UNITED STATES PATENT AND TRADEMARK OFFICE

10/672,526

James Darrin Davis

Office Action Summary

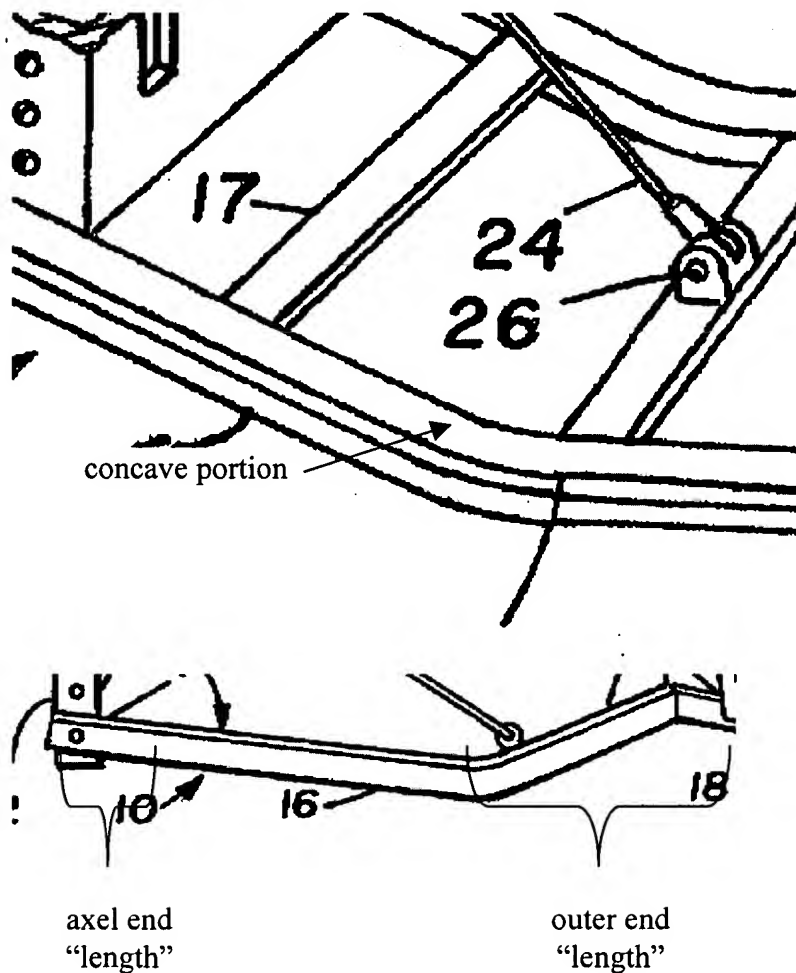
Claims 4, 9 & 14 are rejected under 35 U.S.C. 102(a) as being anticipated by Smith et al. (US 2002/0168257) (previously cited).

With respect to claims 4, 9 & 14, Smith et al. disclose a deer-carrier rack comprising an attaching frame 12 configured for attaching in an upright orientation (FIG. 2) to an end of an all-terrain vehicle, the attaching frame having a lower end and an upper end; and a deer support frame comprising spaced apart left 16 (or 15) and right 15 (or 16) generally co-extensive elongate dog leg rods, each of the rods having an axel end (see below) rotatably attached to the lower end of the attaching frame 12 for generally upward and downward rotation of the deer support frame relative thereto, and an outer end (see below) opposite the axel end and spaced from the lower end of the attaching frame, the outer end of each of the rods having a length which is at least two times greater than a length of the axel end thereof, and the axel ends of the rods forming a concave region adjacent to the lower end of the attaching frame, the concave region being configured and oriented so as to face upwardly while extending downwardly to the outer end of the rod when the attaching frame is attached in the upright orientation to an end of an all terrain vehicle and the deer support frame is rotatably positioned relative thereto in a deployed position extending outwardly

therefrom, the upwardly facing concave region being having a flat outer end which smoothly transitions into the outer end of the rods forming an at least substantially flat, unobstructed platform configured for receiving a body of a deer thereon such that the deer support frame with a body of a deer received on the flat platform can be rotated upwardly from the deployed position to an upright position wherein the outer ends of the rods extend at least generally vertically and the concave region is spaced outwardly from the lower end of the attaching frame for supporting the body of a deer thereagainst without pinching the body of the deer. during the upward rotation, and such that the deer support frame in the upright position can be secured to the attaching frame or the all terrain vehicle for holding the body of the deer against the lower end of the attaching frame.

While Applicant claims an axel end having a concave region and also claims a length (half the length of an outer end length) Applicants figure 5 makes clear that a concave region is part of the axel end. Thus, given the broadest reasonable interpretation the Examiner interprets the axel end to include both a "concave region" and a "length" and combined they comprise the whole of the axel end. A similar analysis of Ellis follows below.
